GENERAL SECRETARIAT INTERNATIONAL TELECOMMUNICATION UNION

CORRIGENDUM No. 1

FASCICLE VIII.2

IXth PLENARY ASSEMBLY OF THE CCITT
MELBOURNE, 1988

Figure A.7/X.21 (page 105)

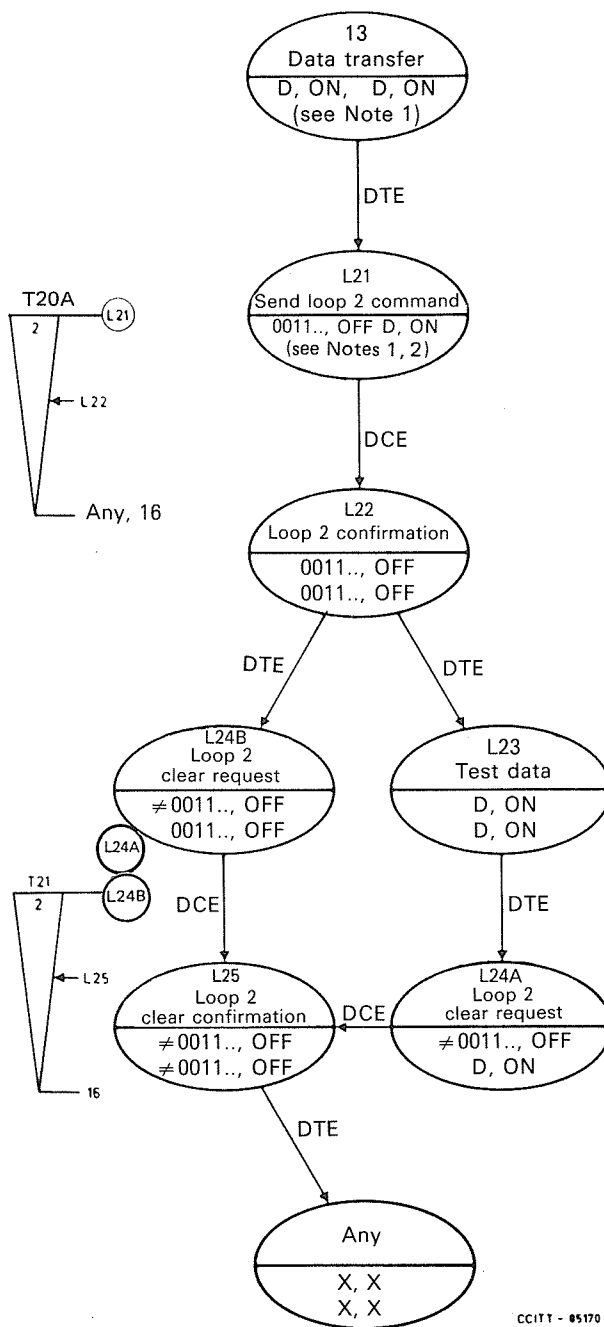
This figure should be improved as shown hereon:

FIGURE B-1/X.21

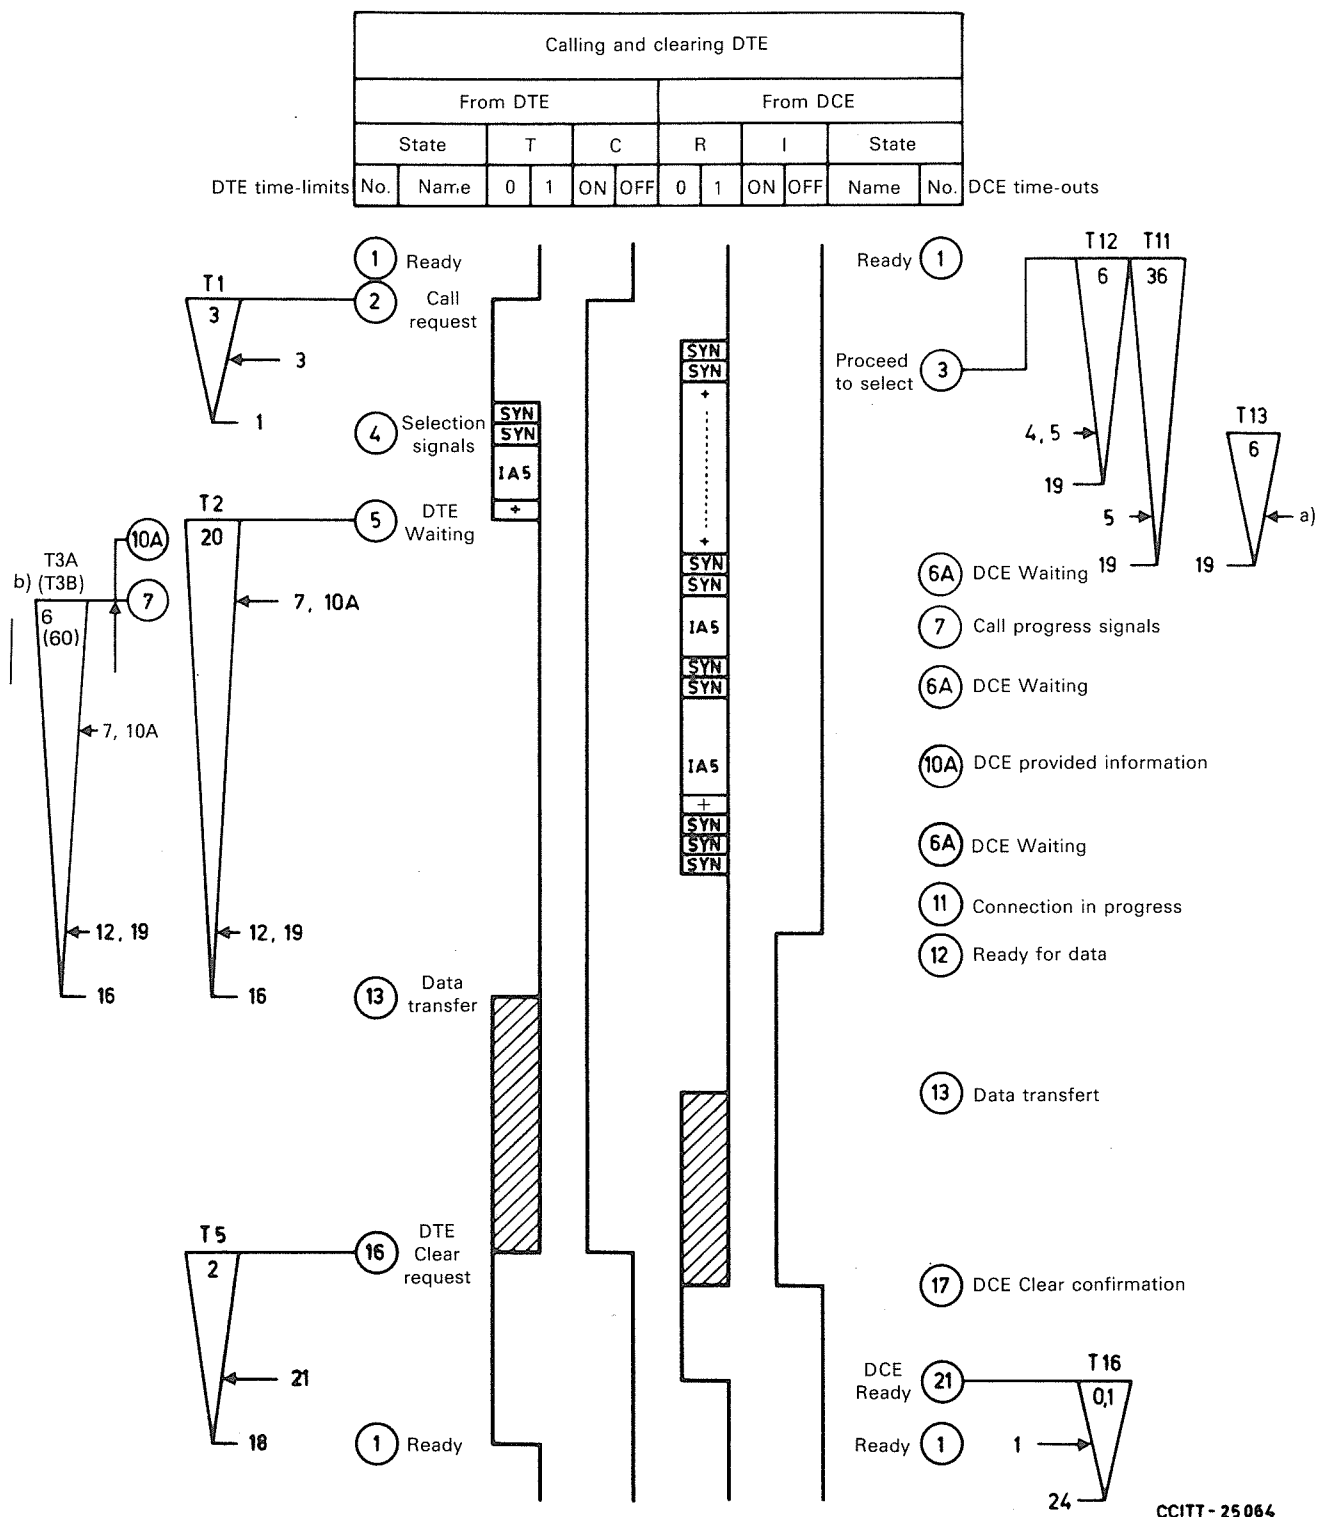
"T20 B" should be closed up and shown as "T20B".

The value of parameter T3A should be added, i.e. "60", a "6" should be inserted as shown below:

FIGURE 5/X.25
Format of the address block when the A bit is set to 1

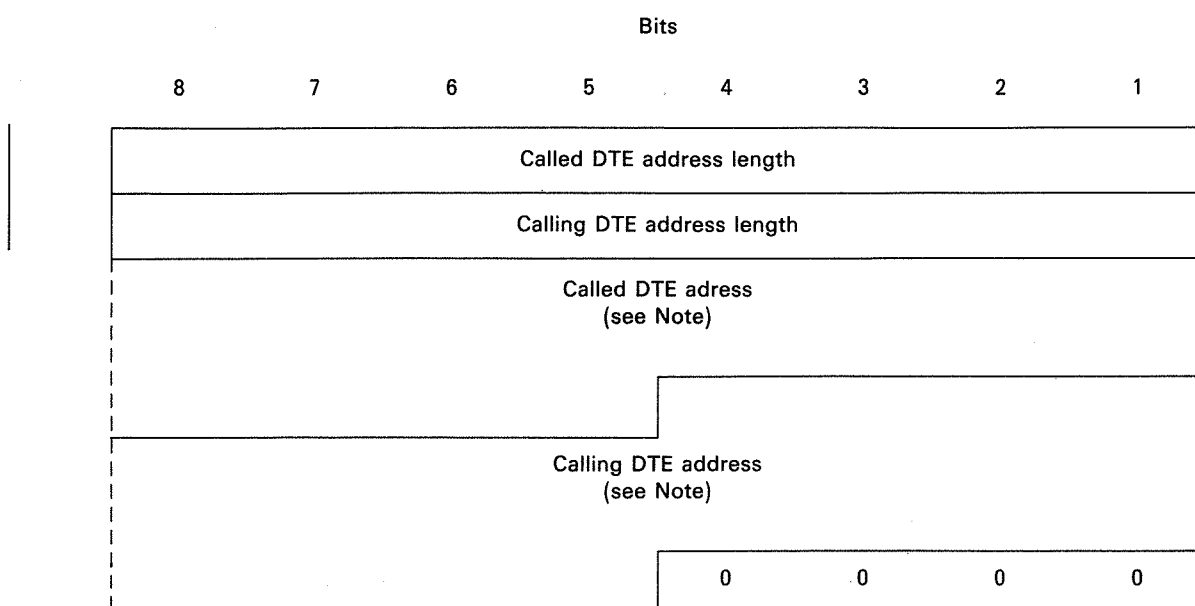
This figure should be replaced by the following one:

FIGURE 21/X.25
Registration request packet format

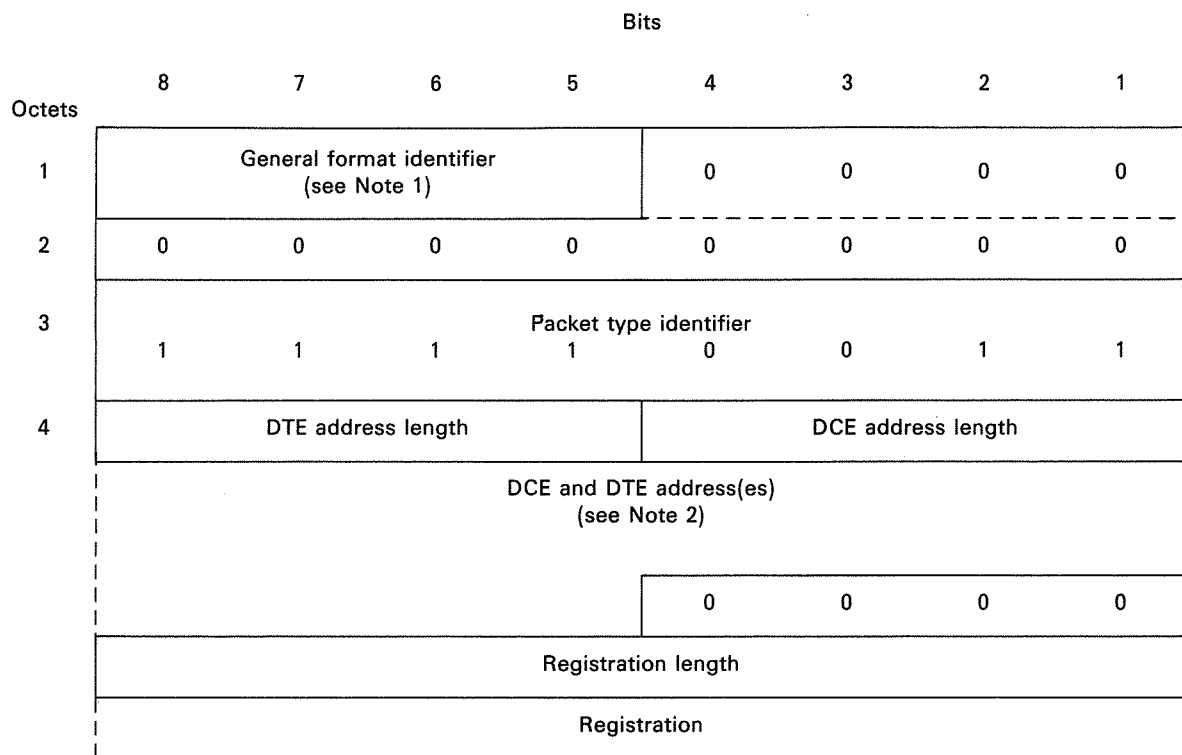
This figure should be replaced by the following one (i.e. in the octet of "Registration length", "0" of bit 8 should be removed):

Figure 1-1/X.30 (page 382)

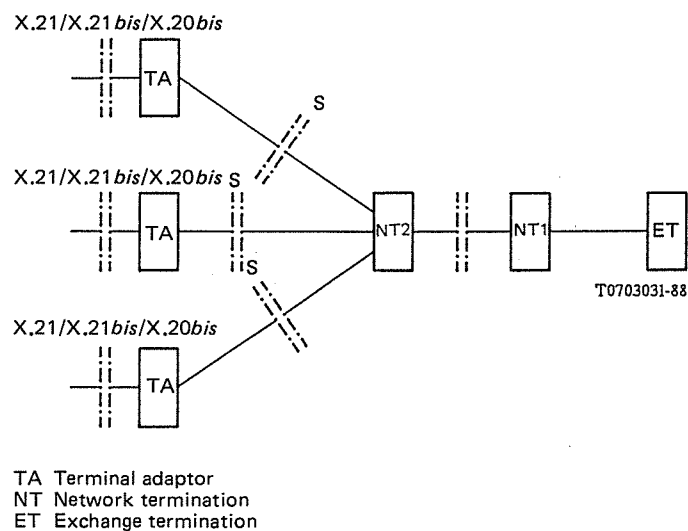
This figure should be replaced by the right one shown as follows:

Figure 2-3/X.30 (page 386)

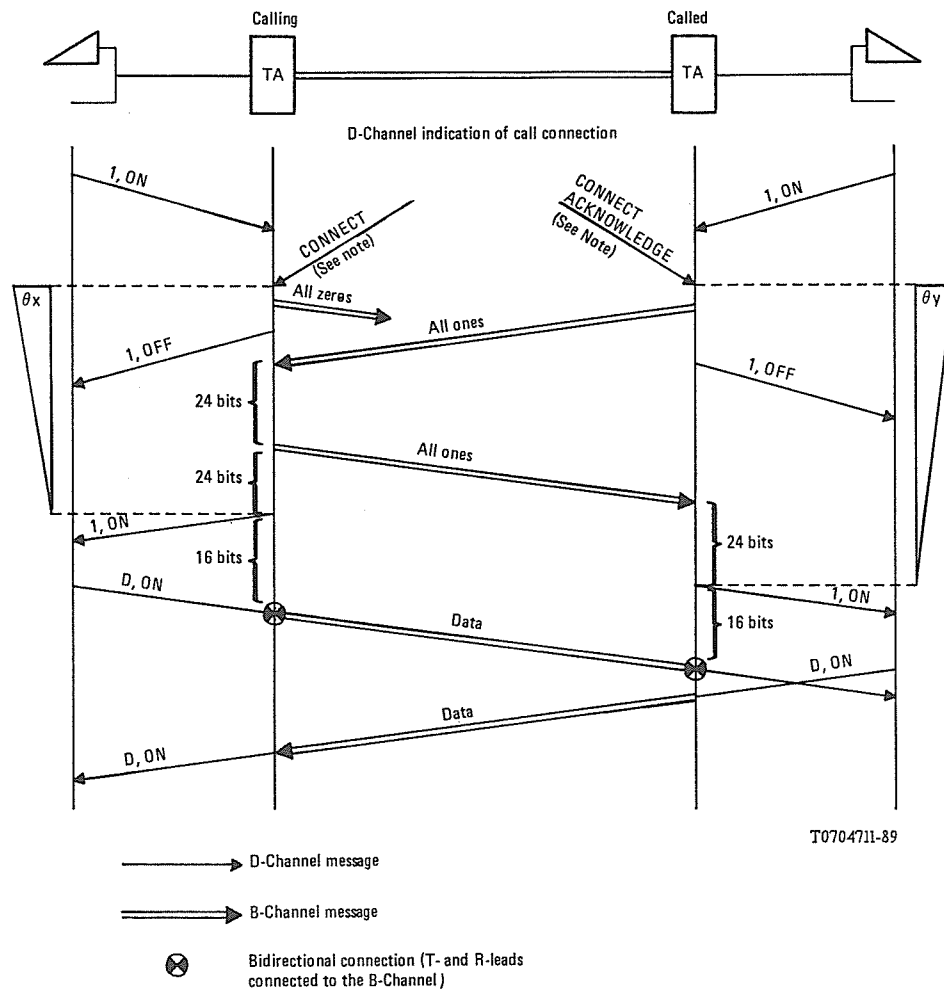
In the sixth block of 8 kbit/s channel,

« 1, Q5.....R2, SP »

This figure should be corrected (i.e. in the middle, "All zeros" should be "All zeros") as follows:

« 1, Q5.....R2, SR »

Figure 2-1/X.31 (page 427)

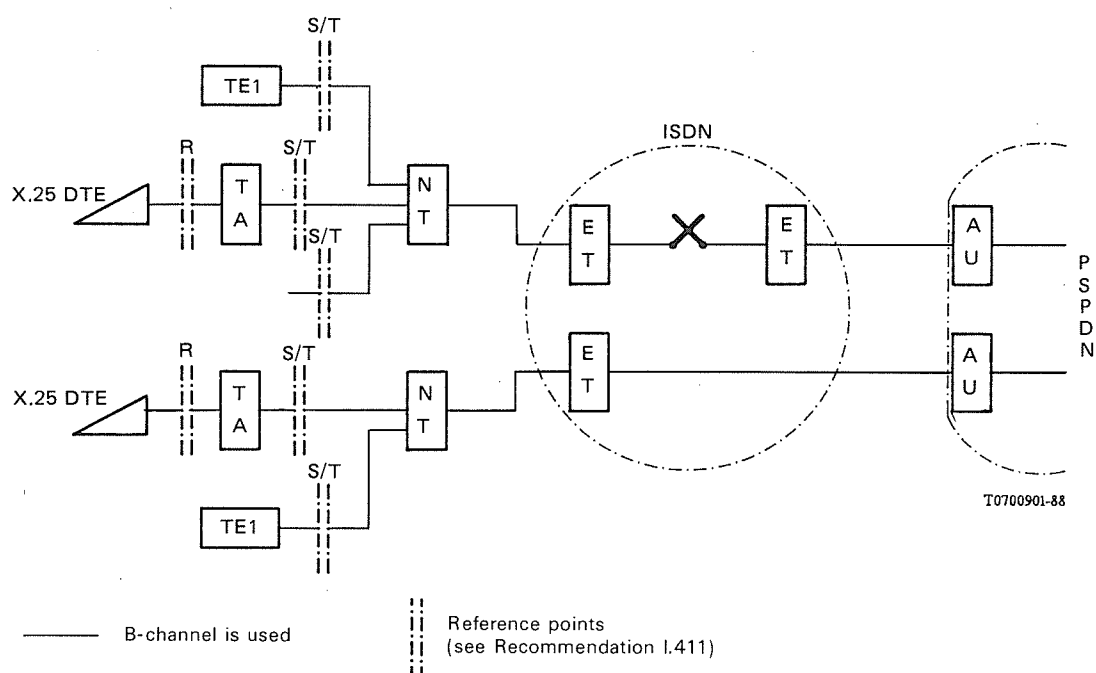
This figure should be corrected as follows, i.e. at the right hand side:
